MANDATORY SERVICE BULLETIN

NUMBER: SB-012 **AMENDMENT 1**

SUBJECT: FUEL SYSTEM; MANDATORY INSPECTION (WING) **AMENDMENT 1**

Figure 1: Fuel Tank Outlet Port

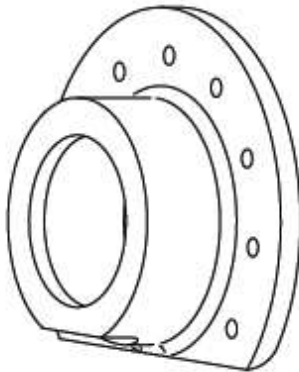
Quest is requiring a one-time inspection of the wing fuel tank outlet port connections. The inspection will consist of ensuring Pro-Seal fuel sealant is present on the threads of the fuel tank outlet port (P/N 100-828-4405).

Inspect the wing fuel tank outlet port connections as prescribed in the instructions attached.
